# Access Compliance Report

## Public Rights-of-Way

Intersection ID: 28501	Main Street: HOLLY_PARK_DR	Cross Street: NORTHWOODS_FOREST_DR	Location: NW
ADA ID: 2AD1F44DD866	Ramp Type: BlendTrans2	Initial Pass/Fail: Fail	Overall Compliance: No
		Severity Score: 47.5

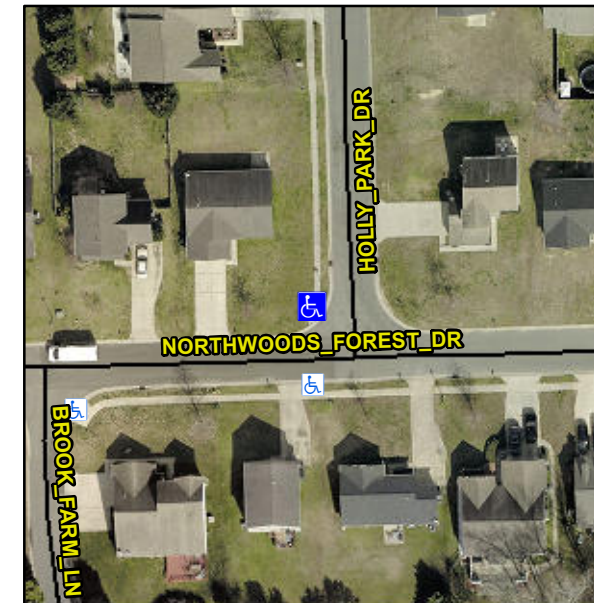
**Not Found, R304.5.1, R304.5.3**

Compliance	Description	Data	Compliance	Description	Data
N/A	Ramp Length (in)	95.0	Yes	BlendTrans Slope (%)	4.4
No	Ramp Width (in)	30.0	No	BlendTrans XSlope (%)	5.9
N/A	Flare Type LT	N/A	N/A	Flare Type RT	N/A
N/A	Flare Slope LT (%)	N/A	N/A	Flare Slope RT (%)	N/A
N/A	Flare Traversable LT?	N/A	N/A	Flare Traversable RT?	N/A
N/A	Landing Length (in)	N/A	N/A	DWS Provided?	N/A
N/A	Landing Width (in)	N/A	N/A	DWS Contrast?	N/A
N/A	Landing Slope (%)	N/A	N/A	DWS Length (in)	N/A
N/A	Landing X Slope (%)	N/A	N/A	DWS Full Width?	N/A
N/A	Landing Curb? (Y/N)	N/A	N/A	DWS Offset (in)	N/A
N/A	Shared Landing?	N/A			
N/A	Gutter Ponding?	N/A	N/A	Gutter Slope (%)	N/A
N/A	Gutter Lip Ht (in)	N/A	N/A	Gutter X Slope (%)	N/A
N/A	Painted X Walk1?	No	N/A	Painted X Walk2?	N/A
	X Walk 1 Direction	To S		X Walk 2 Direction	N/A
	X Walk 1 Width (in)	N/A		X Walk 2 Width (in)	N/A
	X Walk 1 Slope (%)	1.6		X Walk 2 Slope (%)	N/A
	X Walk 1 X Slope (%)	2.7		X Walk 2 X Slope (%)	N/A

N/A	Ramp inside XWalk1?	N/A	N/A	Ramp inside XWalk2?	N/A
	Road Slope (%)	2.7		Clear Space?	N/A
	Road X Slope (%)	1.6	N/A	Clear Space to XWalk (in)	N/A
N/A	Any Obstructions?	N/A	N/A	Storm Grate/Utility Hazard?	N/A
	Obstruction Type			Storm Grate/Utility Type	
		N/A			N/A
			Yes	Surface Condition? (G/P)	Good
			No	Curb Slope (%)	24.7

**Remove & Replace Curb Ramp With Two New Directional Ramps or Equivalent.**
